RE: Agency Comments on the Amendment to Application for Revision 20-1 and Proposed Cost Estimate, Closure/Closeout Plan Update, Cunningham Hill Mine, Permit No. SF002RE

SUBJECT: Additional Comments on Permit Revision 20-1 to Update Closure/Close Out Plan and Financial Assurance, Permit No. SF0002RE, Cunningham Hill Mine

Subject: **New Mexico Environment Department (NMED) Comments, Updated Closure/Closeout Plan, Cost Estimate, and Response to Agency Comments,, Revision 20-1, Cunningham Hill Mine, LAC Minerals (USA), LLC, Santa Fe County, New Mexico, New Mexico Mining Act Permit No. SF002RE**

Figure 1: Open Pit Lake and modeled water level elevations along with events that may affect the open water level (modified Figure 3 from JSAI, 2022).

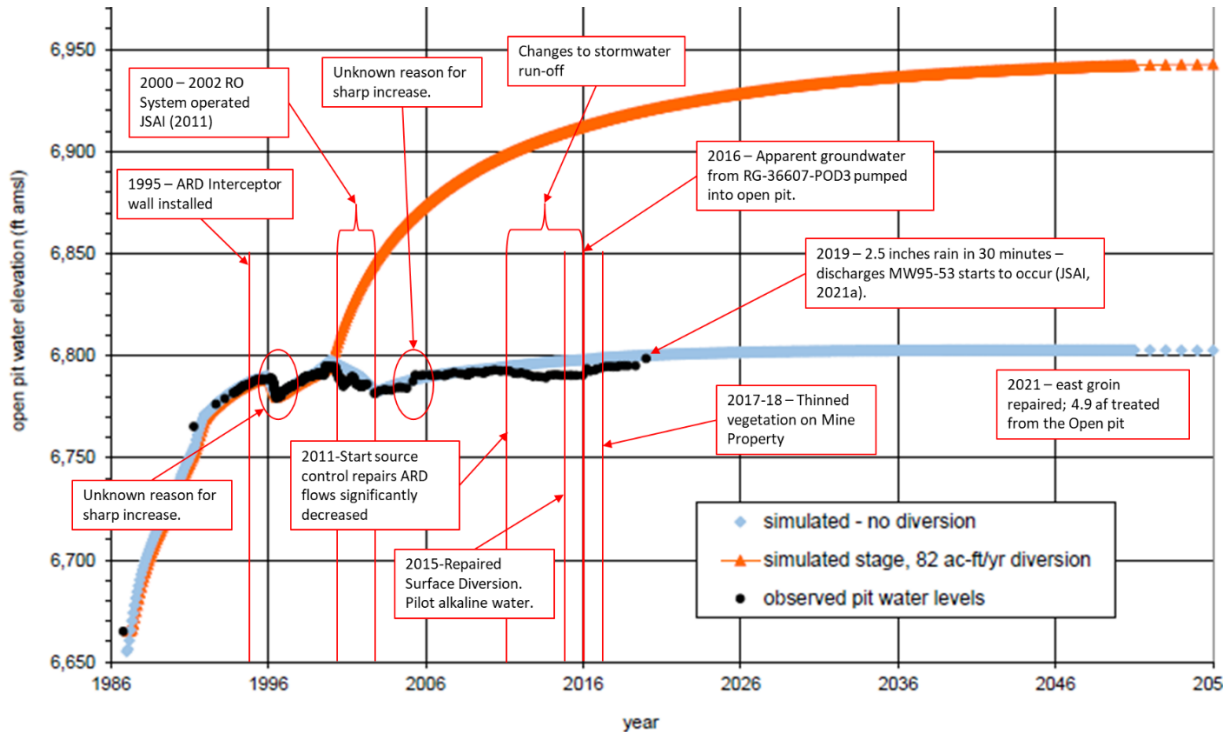
Figure 1 (modified Figure 3 from JSAI, 2022) documents the actual open pit lake water levels and the model results. There are many variations in the open pit water levels. These variations and the changes that may have created are listed below:

- 1) A sharp increase in the pit water level occurs in 2005. No documentation has been supplied for this increase in open pit water level has been supplied.
- 2) There is a decrease in water levels between 2011 and approximately 2013 that does not follow the "No diversion" simulation.
- 3) Between approximately 2013 and 2016 the water levels are relatively flat below the no diversion line.
- 4) In 2016 there was a sharp increase of approximately 5-feet in the open pit water level. This gain in open pit lake water level is not explained by the weir data and may be from

supplemental water being input into the open pit. This input of water would make the water levels appear to follow the no diversion line.

- 5) In 2019, the open pit lake water levels increase to nearly 6,800 ft msl. This nearly 5-foot increase in water level is partly due to a large rain event.
 - a. Surface water diverted into the pit was 20.91 ac-ft.
 - b. RG-36607-POD3 and the residue pile recovery system also pumped 13.61 ac-ft.
 - c. If no evaporative losses were suffered and no other water flowed in to or out of the open pit, then the estimated increase in the open pit water levels would be approximately 22 feet.

- 1) A summary table of all the inflows and outflows from the time mining ceased (1987) to the current time period. This table should include but is not limited to any water that was removed from the open pit lake for remediation, the amount of post treatment water returned to the pit, surface water diverted into the open pit lake, and groundwater that is pumped into the open pit lake.
- 2) A copy of all the current MODFLOW model files for the Cunningham Hill Mine.
